1953 - 1954 Corvette: Service News: Powerglide Clutch Interference

Subject: Powerglide Clutch

Model and Year: 1953 - 1954 Corvette

Source: Chevrolet Service News

Fig. 2—Powerglide Valve Body Re-worked.

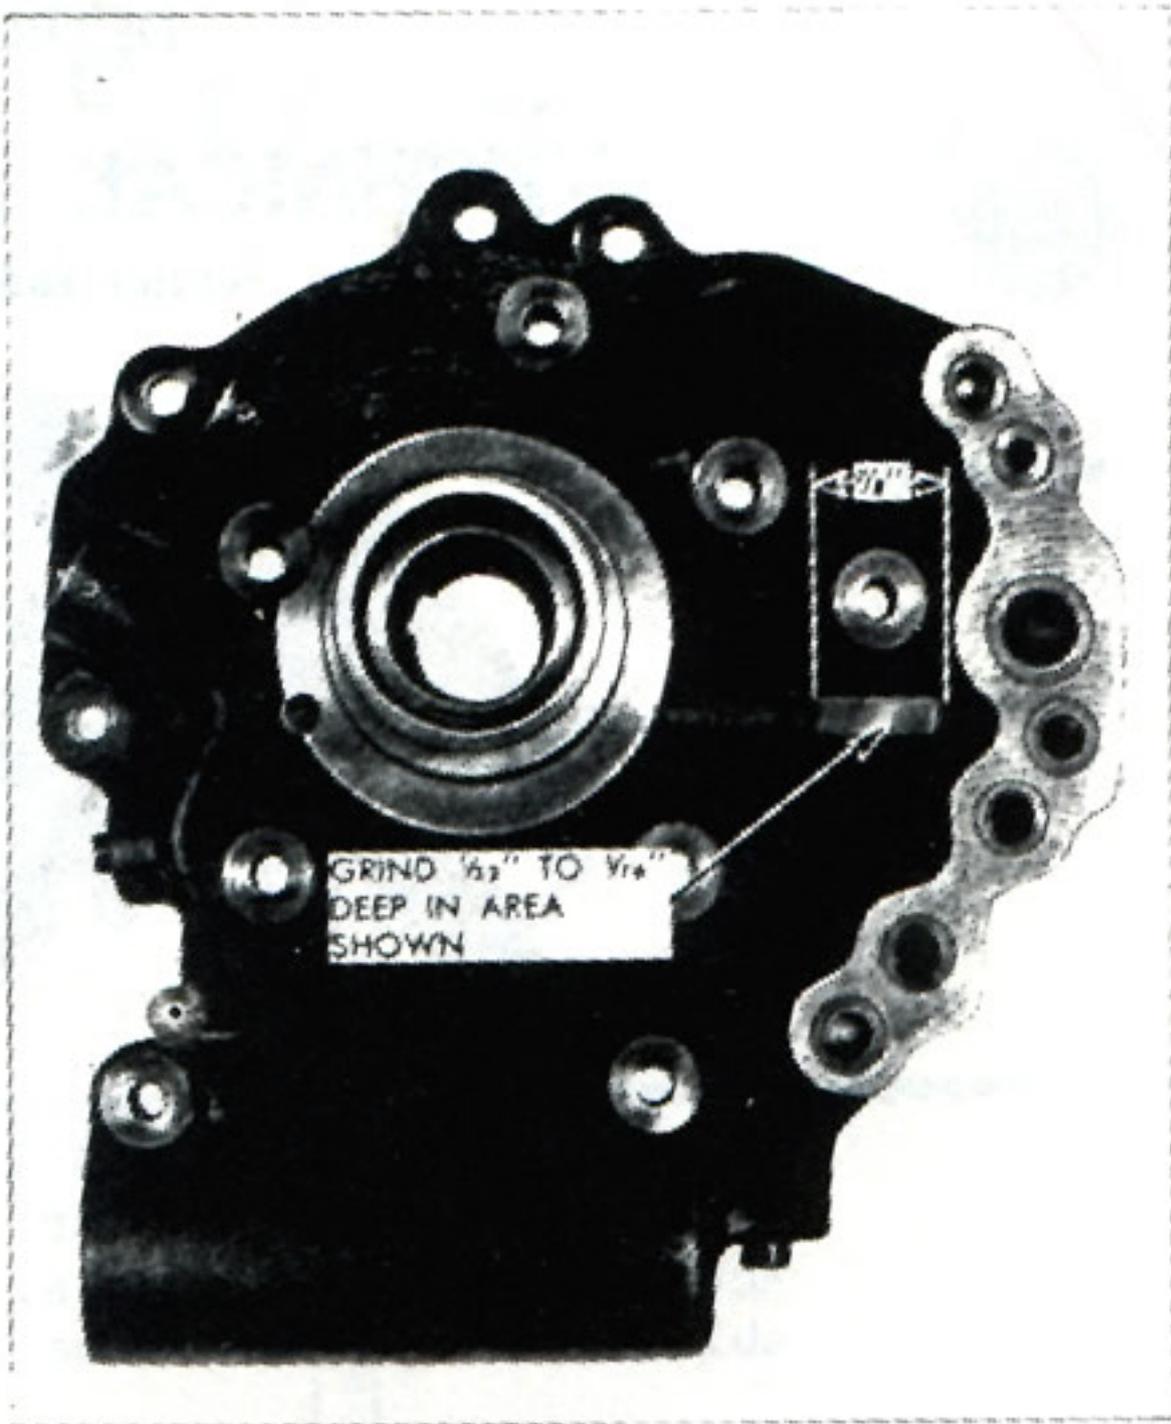
Due to limit stack conditions, a point of interference is possible when using a service replacement clutch drum or clutch assembly in 1953-54 Powerglide transmissions. The difficulty is caused by a ledge incorporated on the front face of a service replacement clutch drum, which can contact an embossed area on the valve body casting.

Where clutch drum-valve body interference is noted when installing one of the above assemblies the valve body must be reworked to obtain drum operating clearance, as shown in Figure 2.
